Subject: USNRC Docket No. 72-1014, TAC L23524  
HI-STORM 100 Certificate of Compliance 1014  
One-Time Alternative to Codes and Standards - Response to Request for Additional Information

## **RESPONSE TO REQUEST FOR ADDITIONAL INFORMATION ASME CODE ALTERNATIVE REQUEST**

Finite Element Model (100 psig pressure)

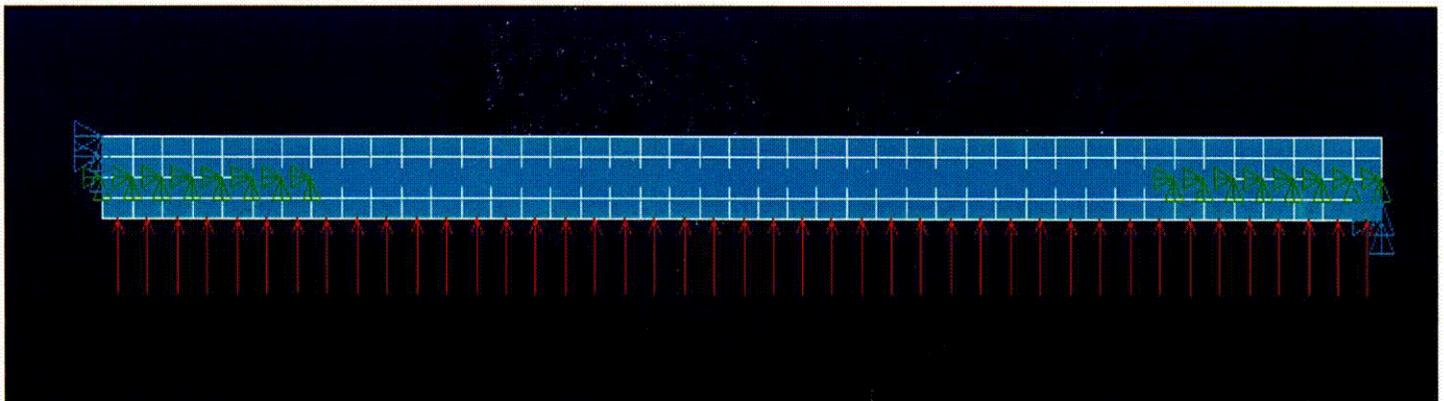
Provide an analysis demonstrating the confinement/structural capability of the MPC closure ring to perform its intended function(s), assuming that the welds for which it is providing a redundant function were to fail (singly or in combination).

This first paragraph of the confinement discussion argues that the closure ring provides a redundant welded closure for the primary confinement boundary, but is not normally pressure retaining. The analysis must demonstrate that the MPC closure ring and welds would maintain confinement and meet Code stress allowables under normal, abnormal and accident conditions. Stating that the MPC closure ring does not normally perform this function is insufficient for demonstrating confinement/structural integrity under postulated conditions. Consideration of the effect(s) of postulated worst-case laminations upon the closure ring attachment welds should be included. For example, an analysis assuming two half thickness plates, simply stacked and otherwise unattached to each other except at the edge welds, may provide the bounding assumption.

Strictly speaking, an internal flaw in the closure ring would produce a localized incremental stress, known as a "peak stress" in the ASME Code. Peak stresses do not have a stress limit, per se. They are significant only in establishing the cyclic fatigue life of a pressure vessel part (Ref. NB-3213.11). However, if the flaw were assumed to be body extensive, such that the flexural capacity of the closure ring is reduced, then the corresponding margin of safety will decrease. To quantify the reduction in the safety margin due to a body extensive flaw, a stress analysis of the closure ring has been performed to determine the effect of an undetected horizontal lamination at the mid-surface of the closure ring. The design pressure of 100 psig is assumed to act underneath the closure ring. The same finite element methodology as is described in HI-STAR FSAR Appendix 3.E was utilized in this analysis. The non-linear finite element model employed to simulate a postulated mid-surface internal flaw that produces a delamination that extends around the entire circumference of the closure ring is summarized below.

To simulate the internal delamination, the mid-surface of the model is defined with a double set of nodes so that the lower two layers and the upper two layers of elements are unconnected. At the inner and outer edges of the closure ring, beyond the flaw, the two sets of nodes are coupled to prevent interpenetration/separation and simulate virgin material. The node sets at the mid-surface within the postulated flaw region are defined to be associated with compression-only contact elements; thus, separation in the middle region of the closure ring is permitted and the lower and upper sets of elements are independent except that normal stress can be transmitted across the interface. The flaw is assumed to extend around the entire 360-degree ring. The radial length of the flaw is varied and the maximum primary stress intensity computed. After iterations on radial flaw length, the maximum flaw radial length (to meet the Level A stress intensity limits) extends from  $r = 27.795$  inches to  $r = 32.642$  inches; the ratio of flaw span to total span is  $4.847/7.188 = 0.674$ . The presence of the lamination does not affect the shear capacity of the closure ring, which means that the safety margin of 1.24 reported in the FSAR is unaffected. The figure below shows the model.

The results from the finite element analysis establish that the maximum extent of the all-around flaw permitted without exceeding ASME Code allowable limits is 4.847" out of the total 7.1875" width. In other words, the mid-plane flaw can extend to two-thirds of the total closure ring width around the entire circumference of the closure ring before the computed stress intensity begins to approach the allowable value. This represents a postulated extent of flaw that is wholly inconsistent with industry experience with ASME Section II-certified thin austenitic stainless steel plates
